HEARING REPORT
NOTICE OF REQUIREMENT
56 MIDDLEFIELD DRIVE, FLATBUSH
MINISTRY OF EDUCATION

**A NOTIFIED NOTICE OF REQUIREMENT TO THE AUCKLAND COUNCIL UNITARY PLAN
BY MINISTRY OF EDUCATION**

Requiring authority	Ministry of Education
Notice of requirement reference	Alteration of Designation 5007 at Willowbank Primary School for education purposes – primary school [years 0-8] and Early childhood education [ECE]
Resource consent applications	No resource consent applications have been lodged by the requiring authority for this project.
Reporting planner	Vanessa Leddra, Policy Planner Central / South
Site address	56 Middlefield Drive Flat Bush.
Lodgement date	12 January 2022
Notification date	27 January 2022
Submissions close date	25 February 2022
Number of submissions received	Total: 3

Figure 3.1 Extent of school traffic parking in mornings

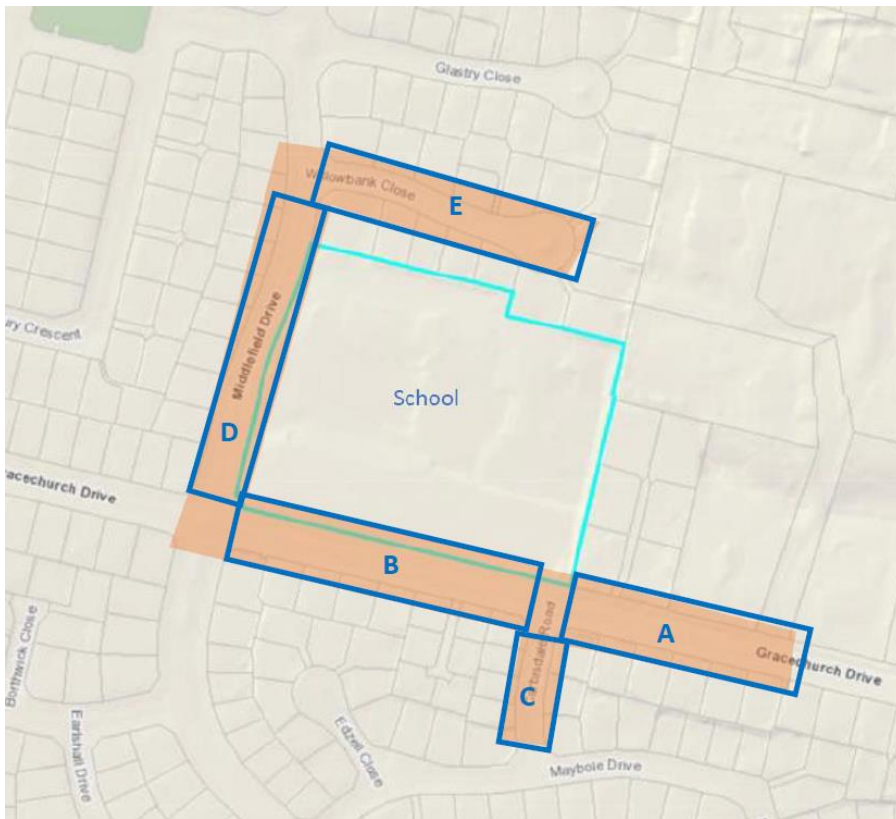
<p>3. Please provide a map showing the physical extents of the survey areas A to J noted in the appendix to the TA.</p>	<p>Figures 3.1 and 3.2 are updated with parking zones labelled A to J.</p>
<p>4. During Mr Edwards’ visit to the area on the afternoon of 19 November he observed school-related on-street pick-up parking in streets not included in the TA survey, including Rialto Court and Thornberry Crescent. Please expand the physical extent of the on-street parking survey to include a wider area, including at least those streets identified above, to ensure that all areas used for pick-up and drop-off parking are measured. Note – it may be beneficial to provide a better understanding of the on-street parking situation if the surveys covered a longer period before and after school to cover the increase and decrease in parking demand.</p>	<p>The drone footage didn’t always capture Rialto Close and Thornberry Crescent. However, we’ve undertaken further analysis from the drone footage that is available for this area and conclude that in the mornings, these streets were not utilised for school pick up and drop off. However, in the afternoons, there was school traffic utilising these streets, with approximately 30-40% parking availability remaining throughout the afternoon pick up period. We have not updated the parking survey results to include these roads as the data is not regular enough to match the data on the surrounding roads, and it will not dramatically change the results. In fact, it would result in a favourable result as the addition of Thornberry Crescent would increase the average parking capacity in proximity to the school.</p> <p>In regard to extending the survey times. The morning survey time started when children are allowed to enter the school grounds (8.30am) and finished once the school bell rang. In the afternoons, the surveys started 5 minutes prior to the school bell ringing and finished once the majority of the children had left the premises. It is recognised that caregivers likely arrive prior to 2.55pm for the afternoon pick-up however at every other time it would be unlikely that there would be any school traffic to survey. Extended</p>

Figure 2: Proposed relocation of pedestrian crossing from masterplan

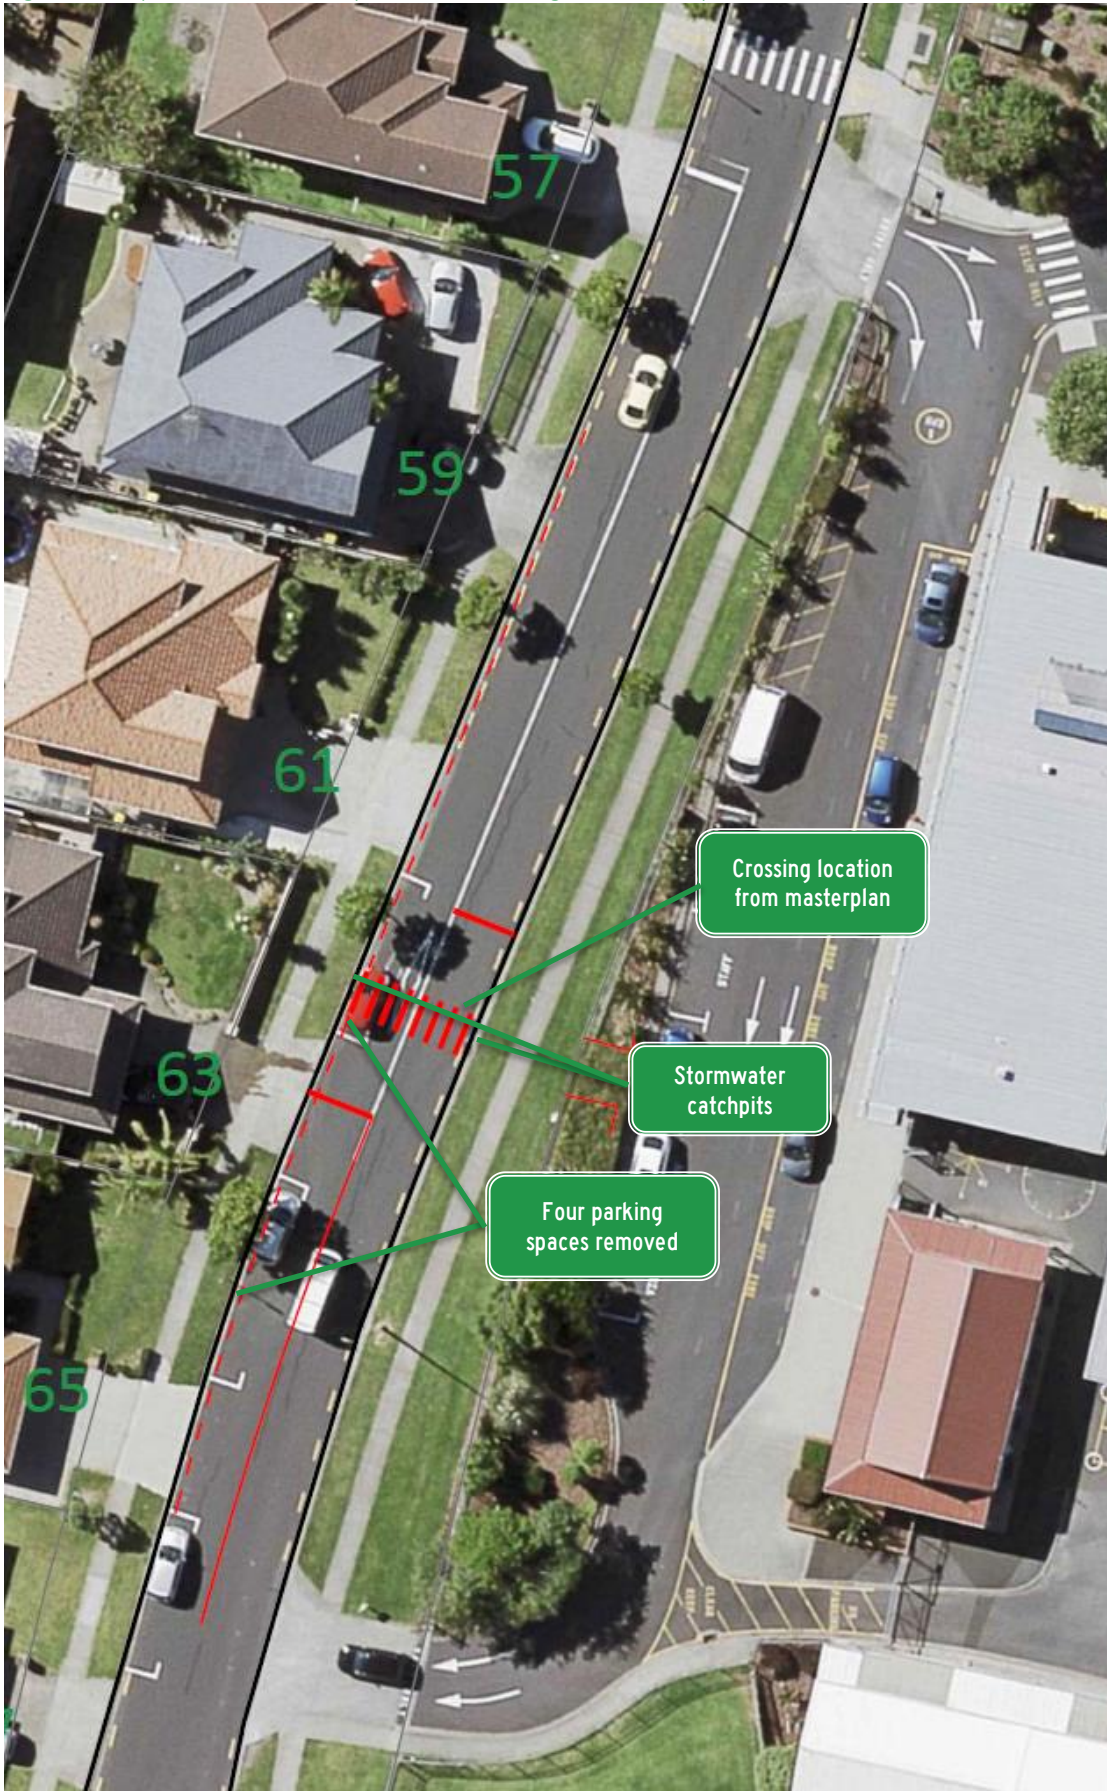
The TA assess some changes to the PUDO area including some on-site changes and relocating the existing zebra pedestrian crossing on Middlefield Drive.

The zebra crossing is currently located immediately north of the school's northern access. The masterplan indicates the crossing could be moved approximately 60m south. The image above shows the existing arrangement of Middlefield Drive from Council's GIS system and the location of the relocated pedestrian crossing from the masterplan provided with the notice.
